ADDENDUM TO FREQUENCY MOD FOR HALICRAFTERS

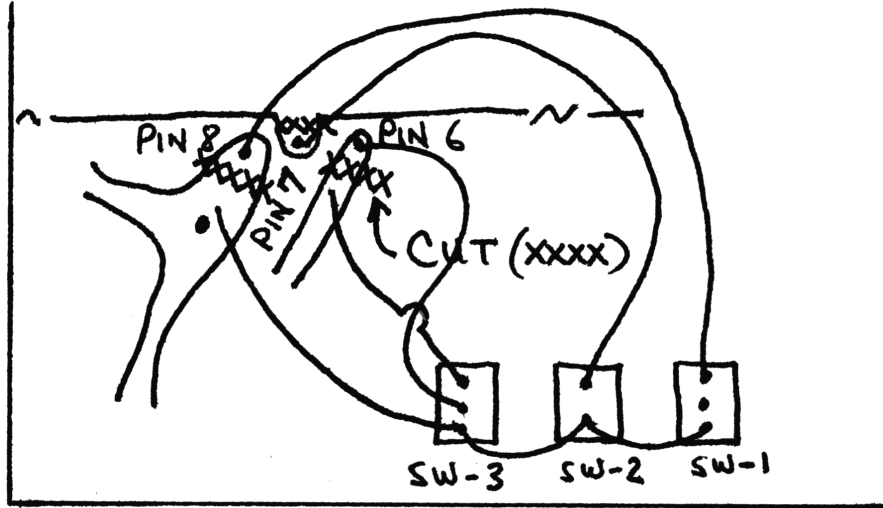
The addition of SW-3 will give: (SW-1 ON, SW-2 OFF, SW-3 ON)

With SW-1 ON, SW-2 ON and SW-3 ON, channel positions 1-27 will give frequencies from 27.885 thru 28.195.

You must use double pole switch for SW-3 in order to maintain normal operation.
